306 Market Street  
Brookville

HAWP 23/65-08A

## HISTORIC PRESERVATION COMMISSION

SUBJECT: **Stop Work Order:** Historic Area Work Permit #518318 - 306 Market Street, Brookeville.

# Elevation Drawing - cedar RAILINGS

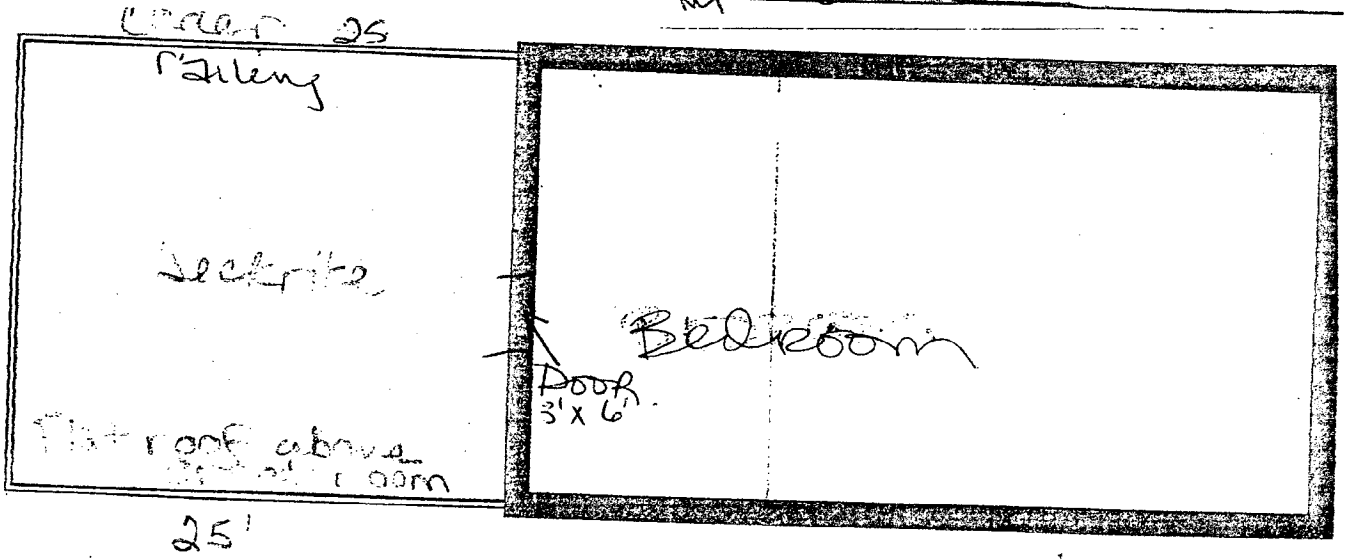
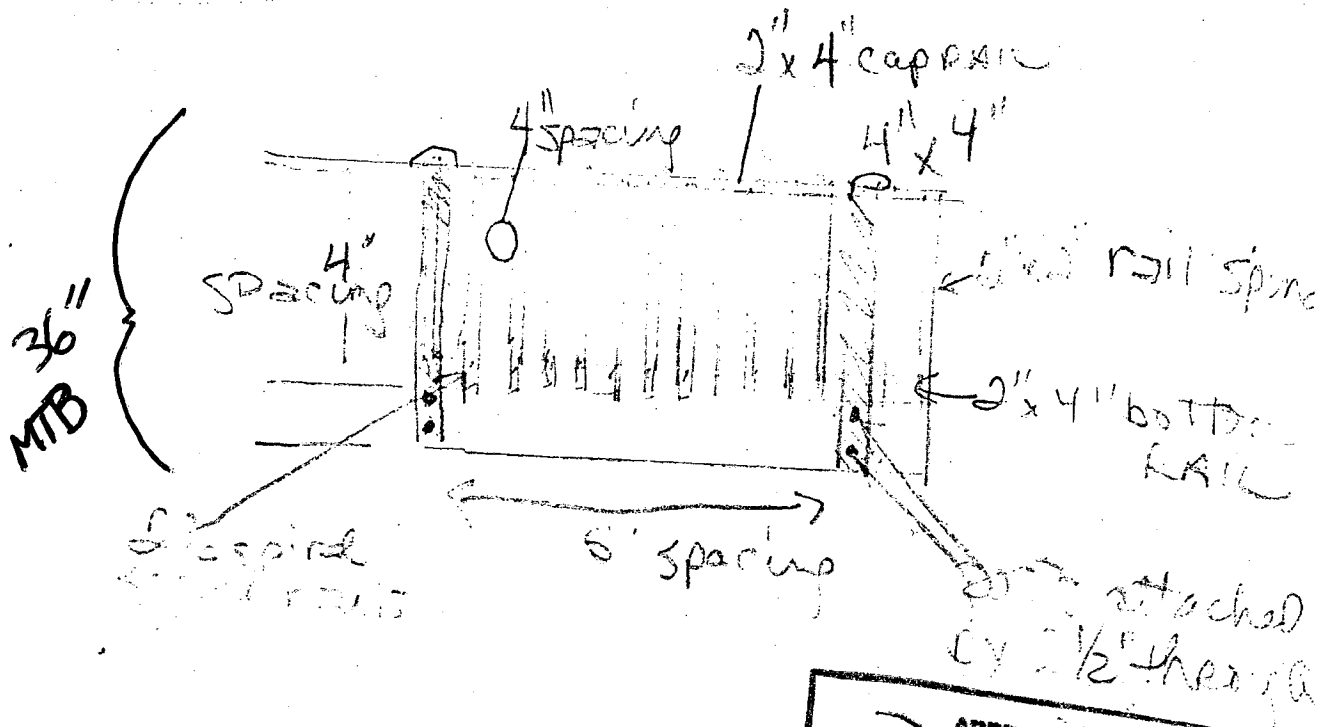
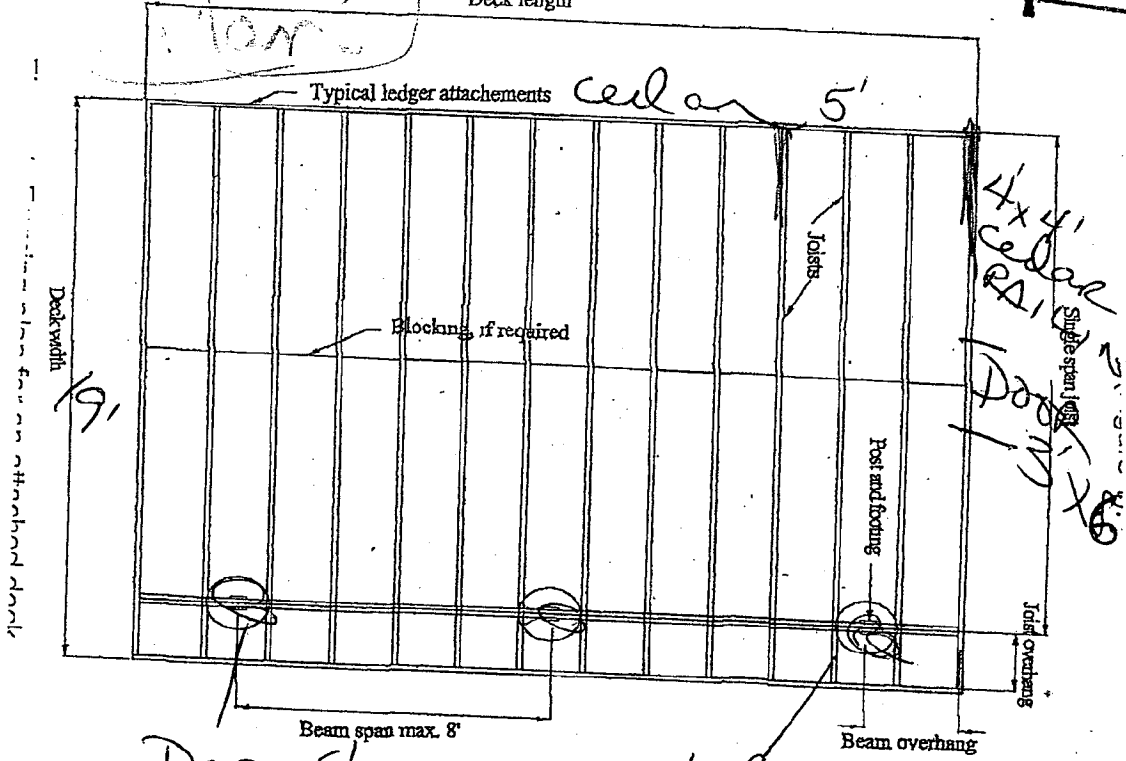
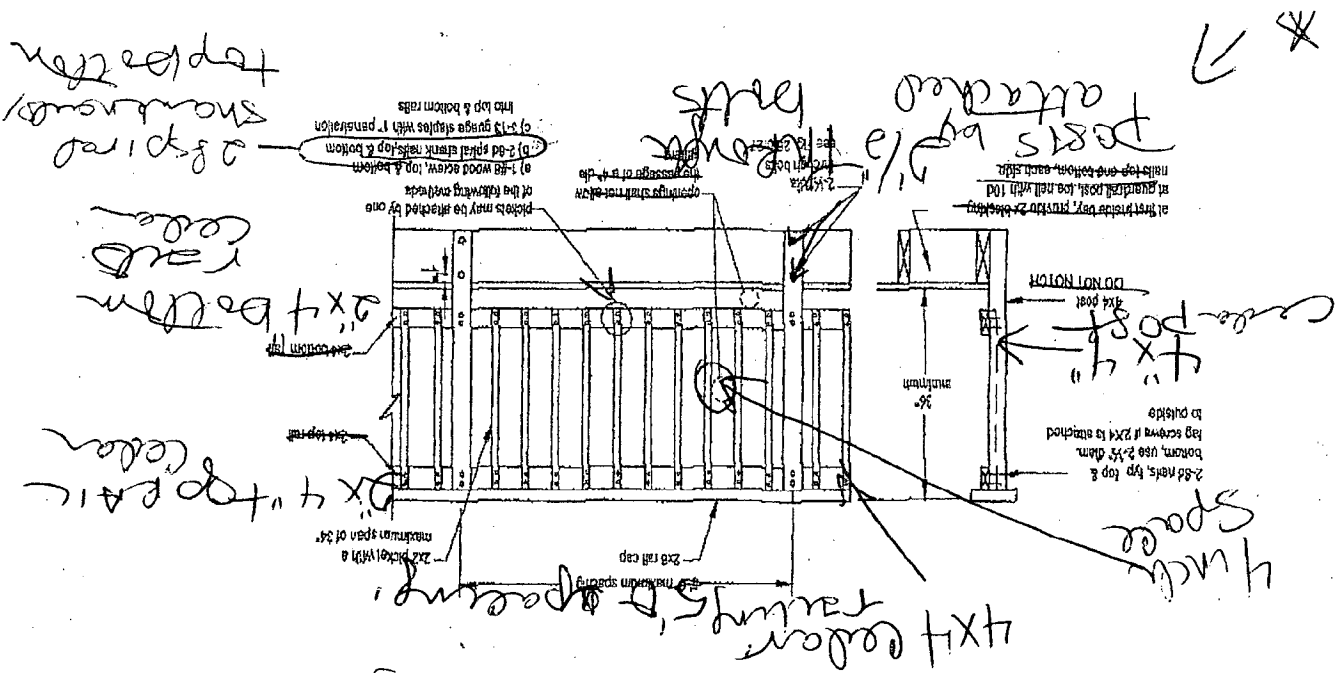
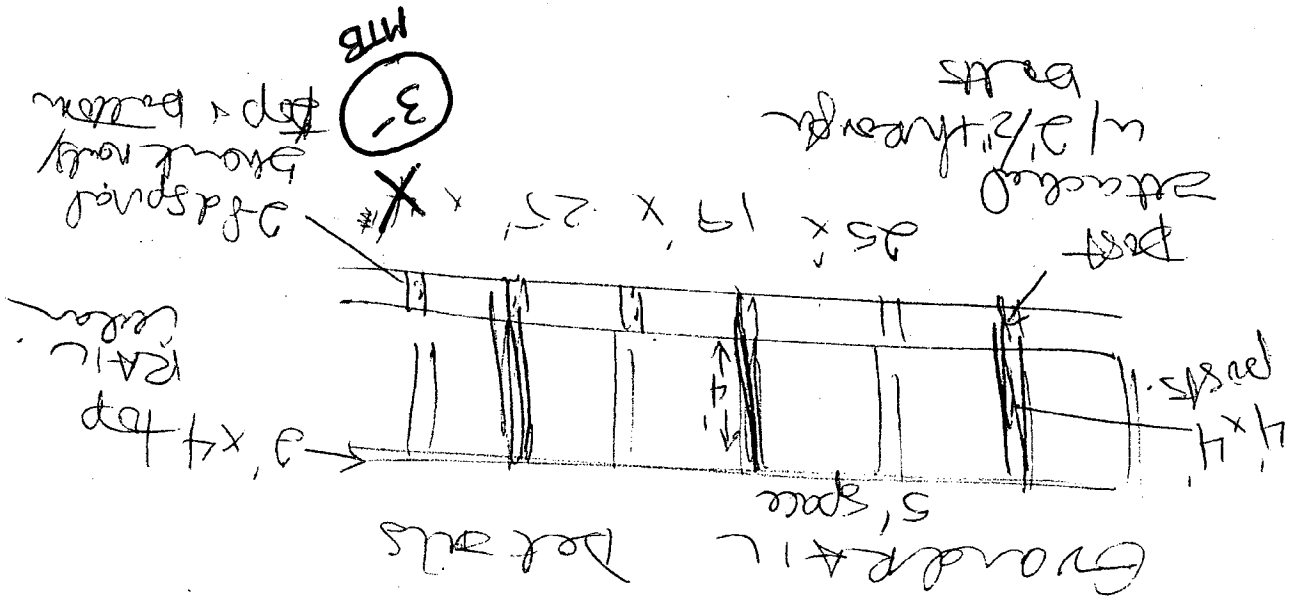
The Montgomery County Historic Preservation Commission (HPC) approved the installation of a 36" tall, wood, inset picket railing along the edge of the flat roof of the non-historic rear addition at 306 Market Street, Brookeville, Maryland at their Wednesday, September 23, 2009 meeting as part of Historic Area Work Permit #518318.

This HAWP approval is subject to the general condition that the applicant will obtain all other applicable Montgomery County or local government agency permits. After the issuance of these permits, the applicant must contact this Historic Preservation Office if any changes to the approved plan are made. Once work is complete the applicant will contact Matt Bowling at 301.563.3408 or [matt.bowling@montgomeryplanning.org](mailto:matt.bowling@montgomeryplanning.org) to schedule a follow-up site visit.

East Porch

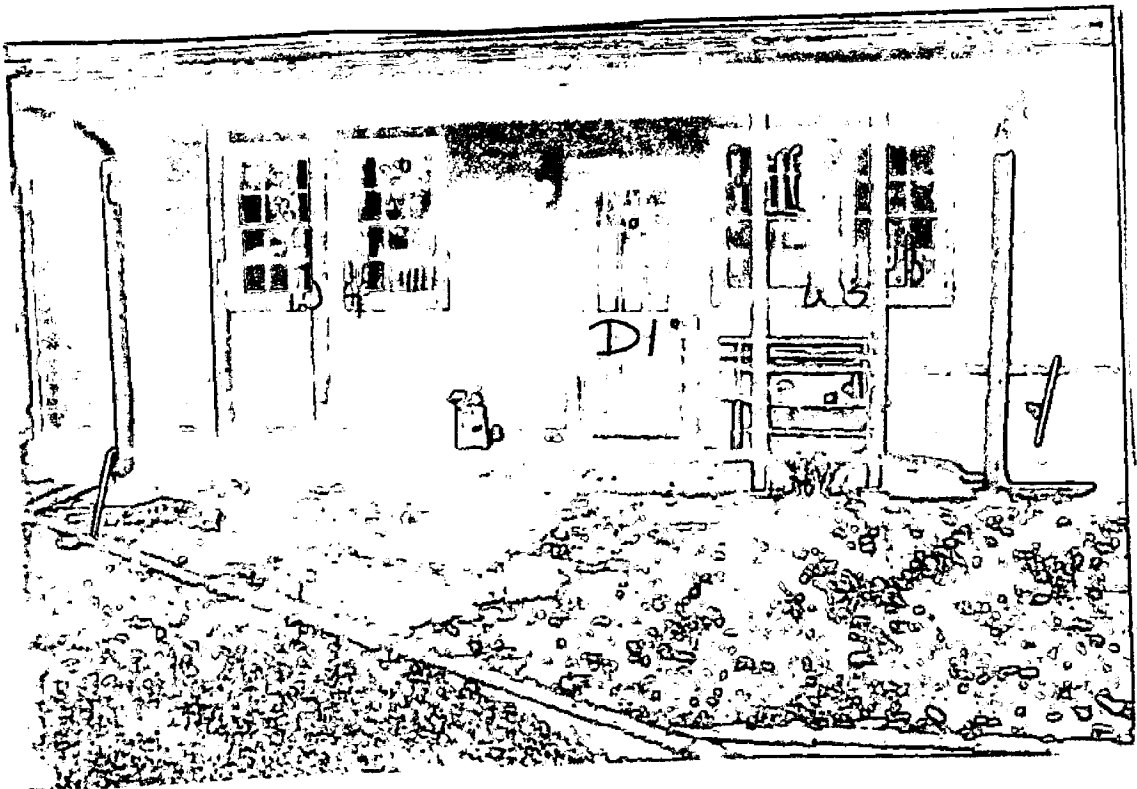
We removed damaged trellises on the east porch. We moved a porch post already in existence on each side to the front so there are now 3 supporting posts (each post is 4"x4").
